SPRINGS AT WATERVIEW - AMENDED STORM

GRINNELL DITCH NORTH - PLAN / PROFILE

GRINNELL DITCH SOUTH PROFILE

STORM B PROFILE

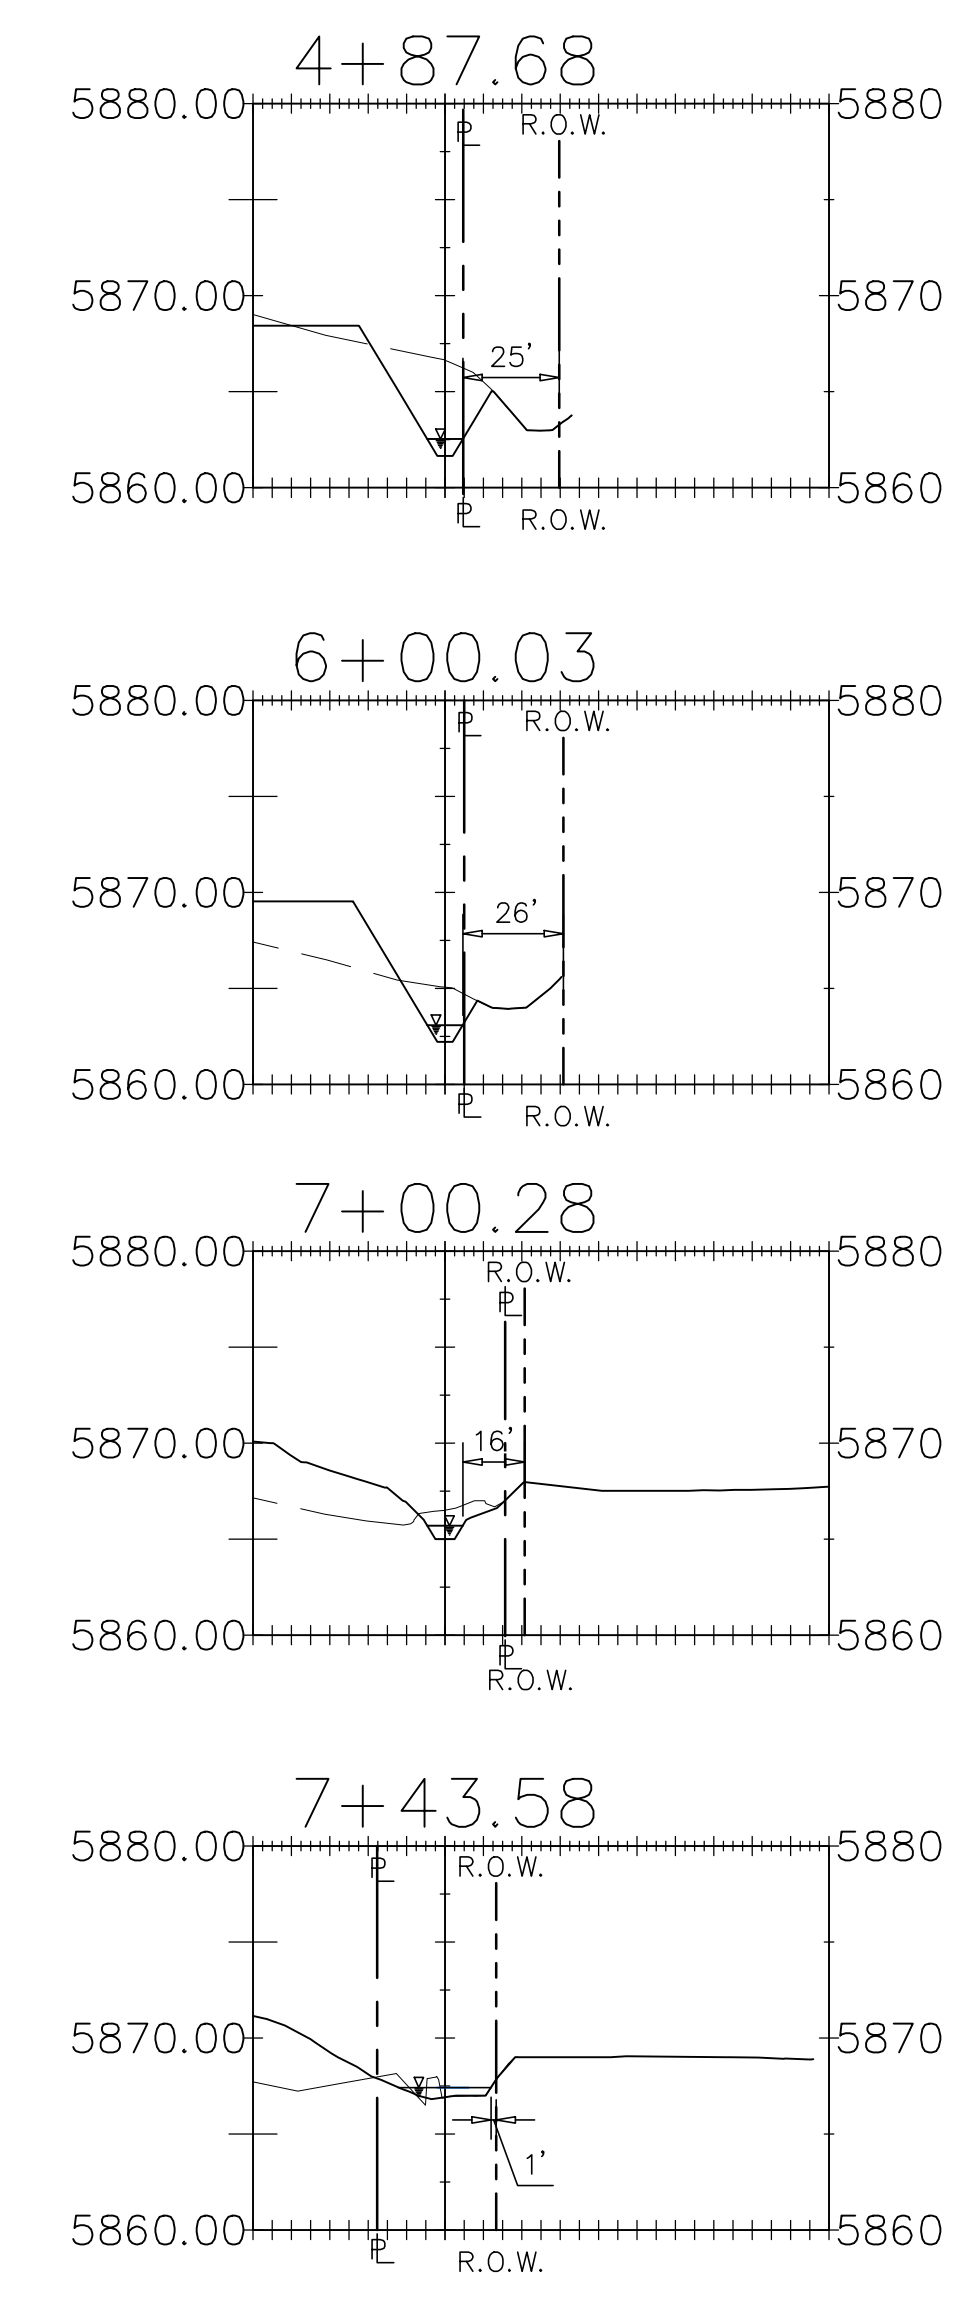
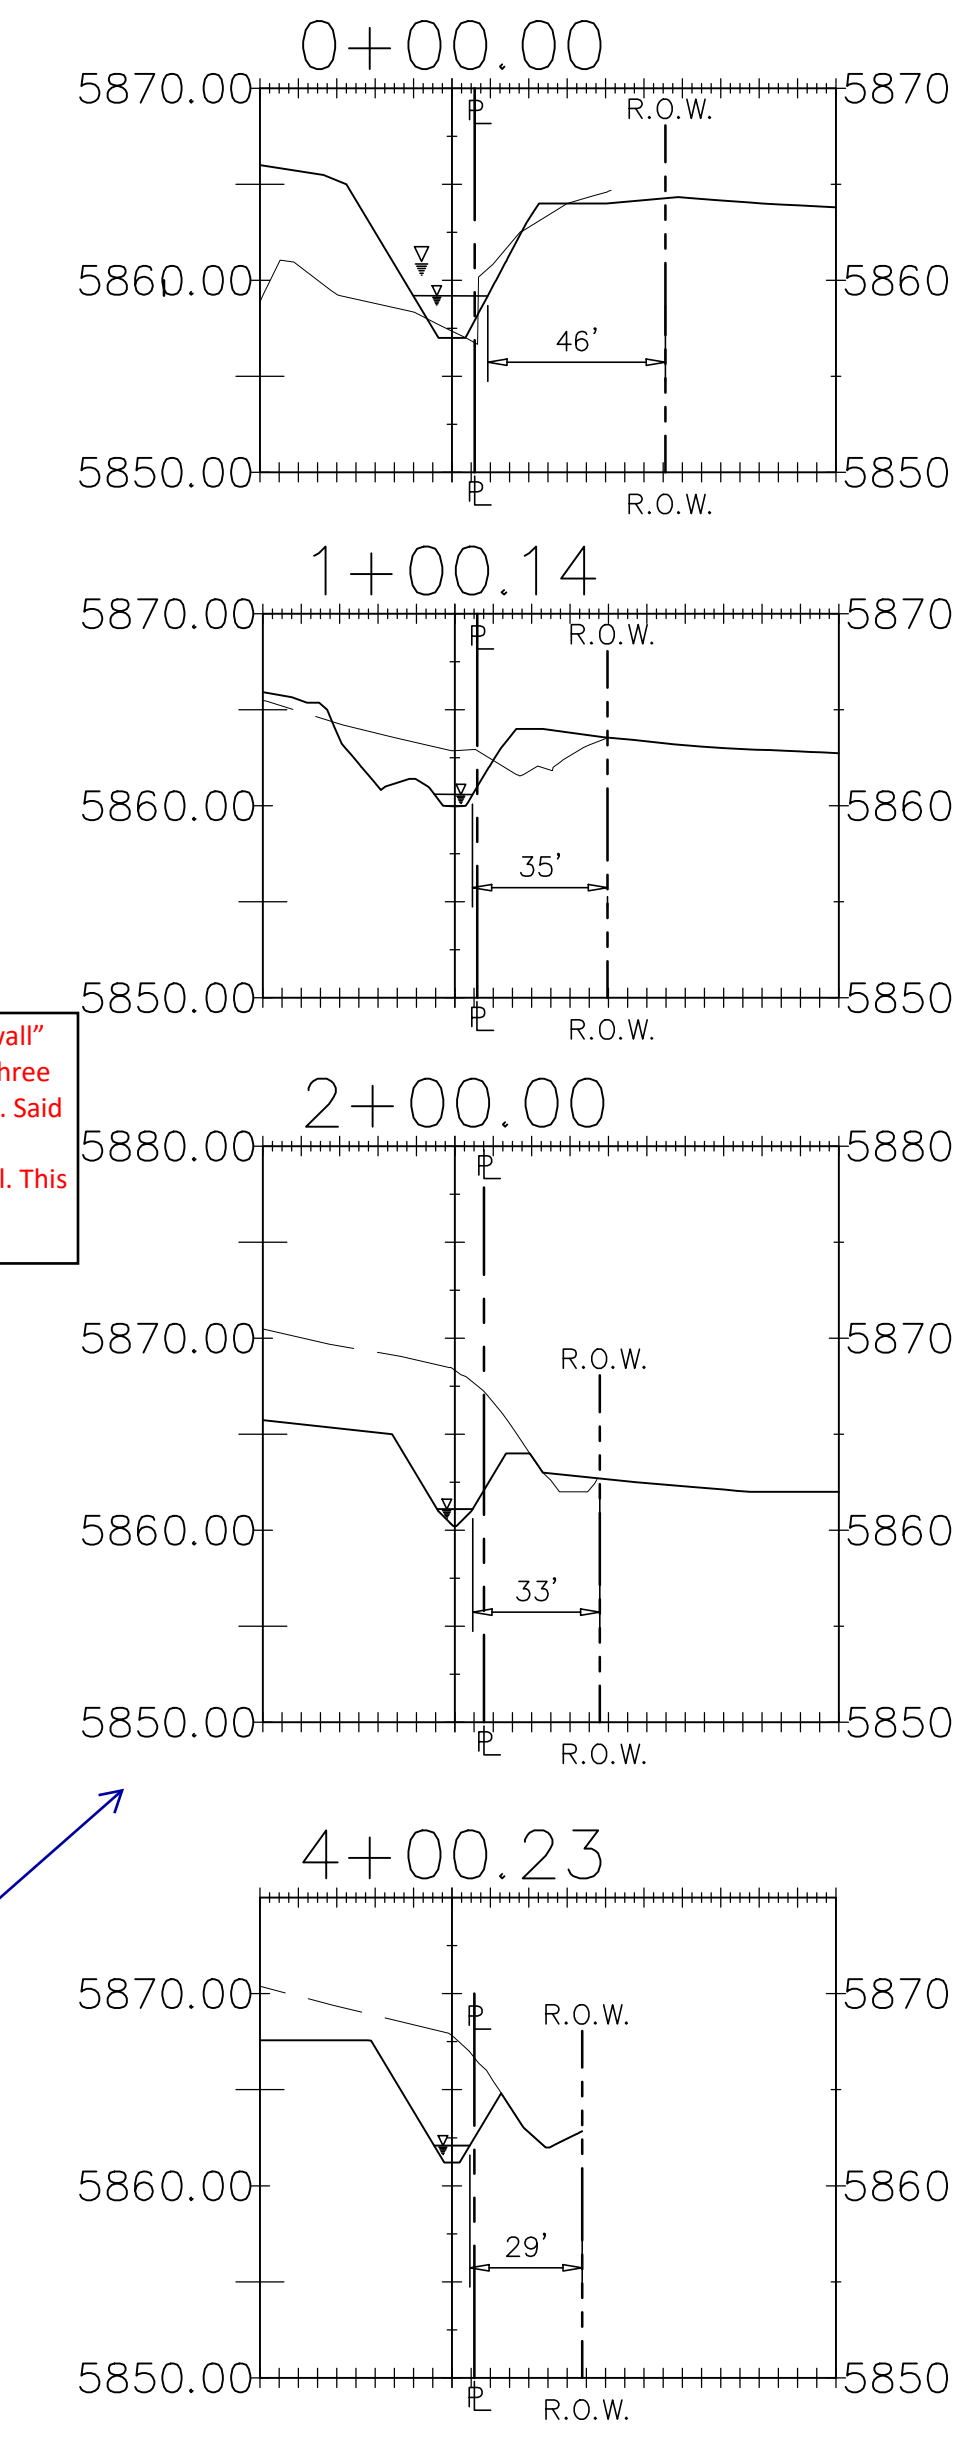
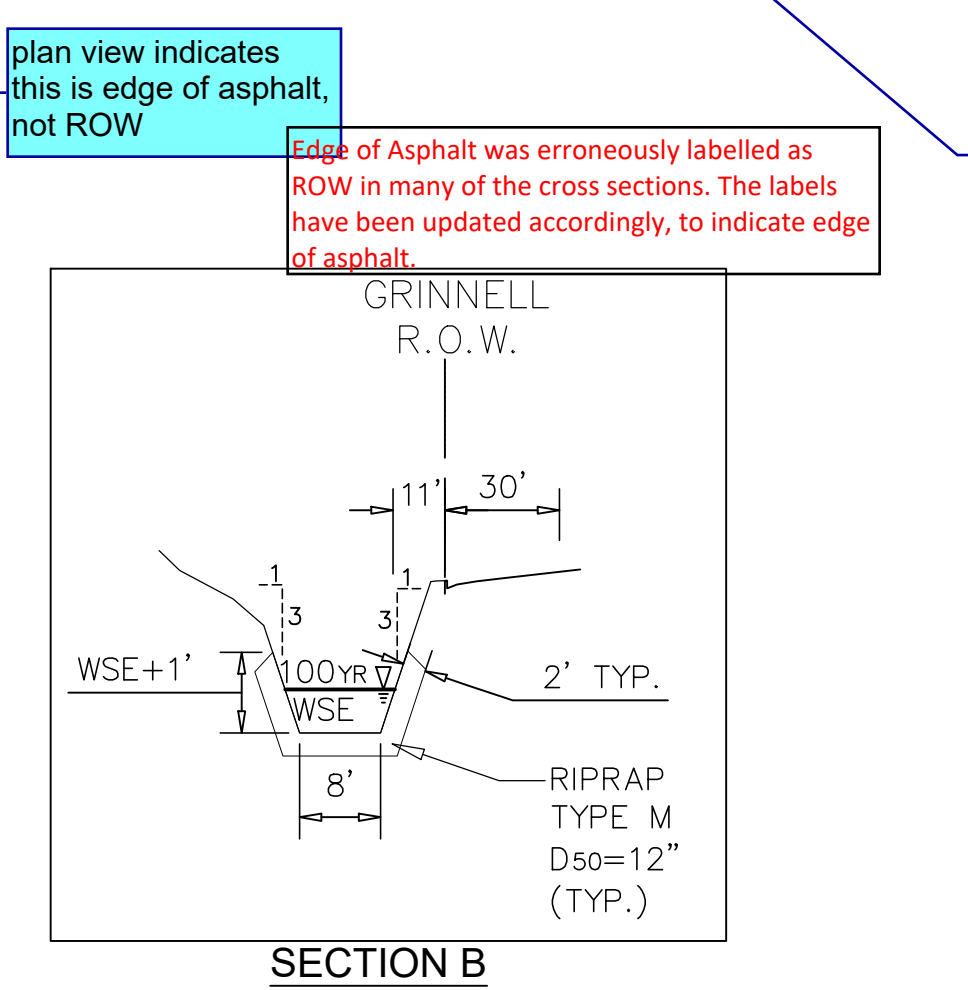
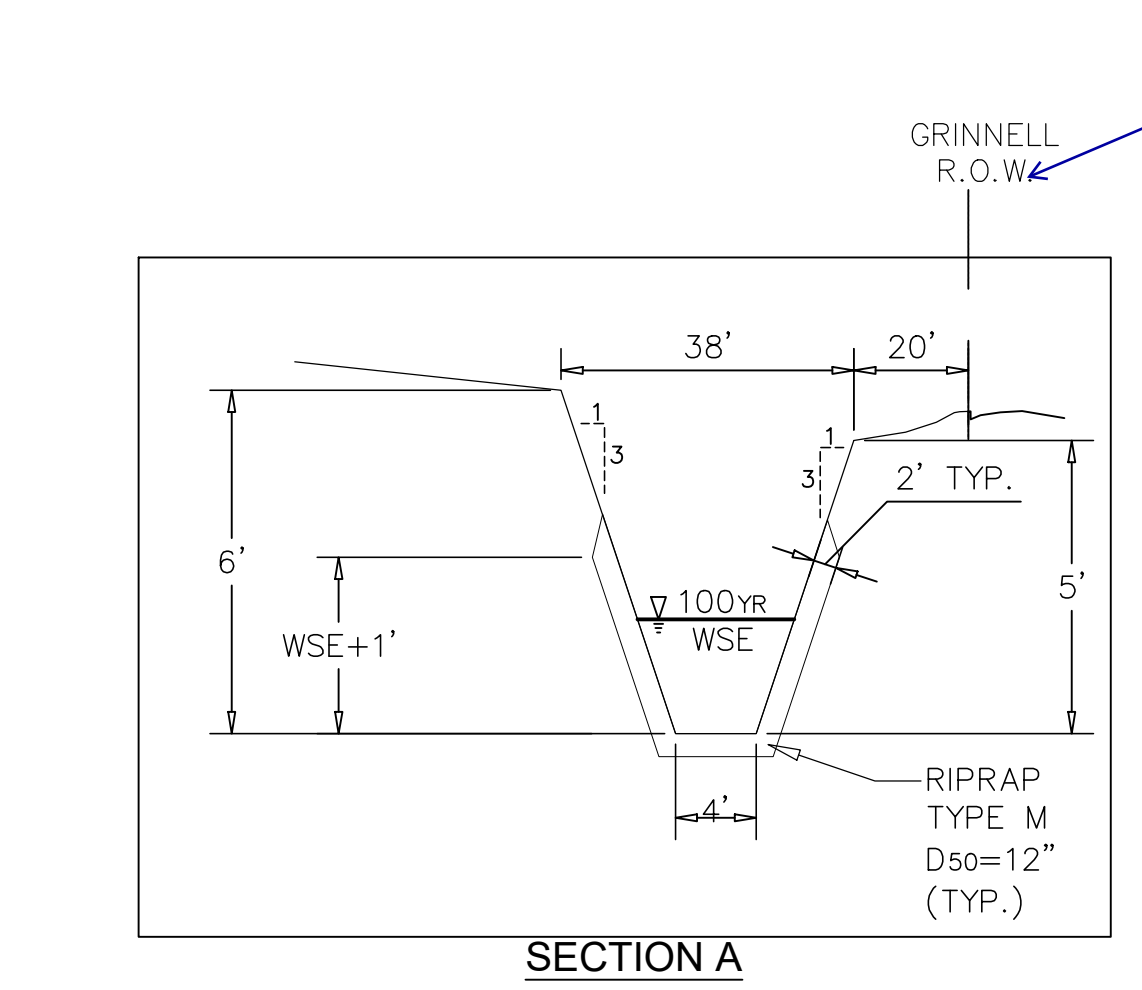
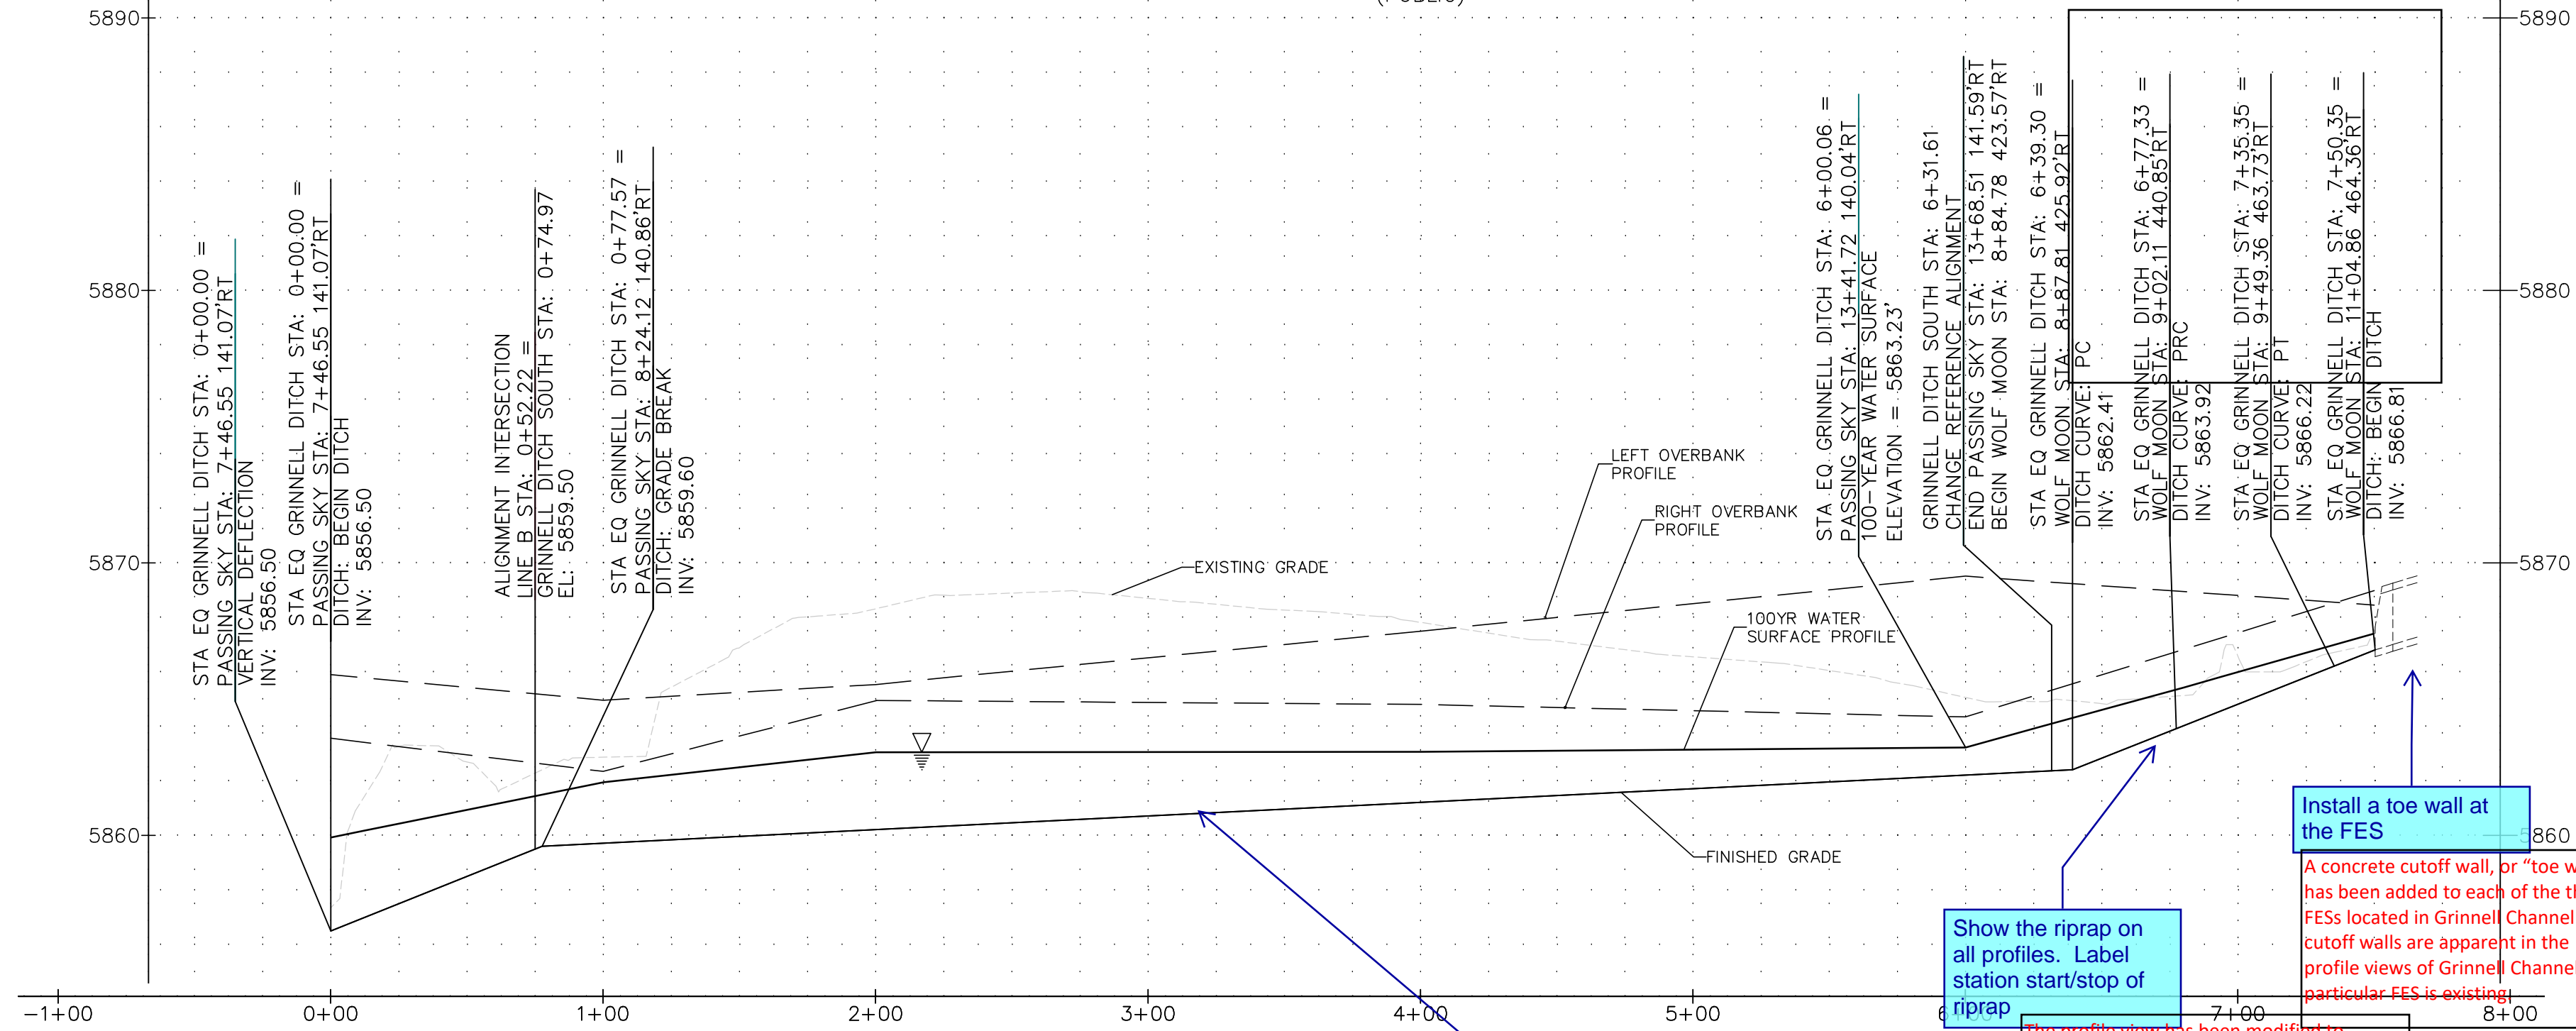
Provide delta angle

See previous page for comments regarding the cross sections

The horizontal control table has been modified to include delta angles for the curves.
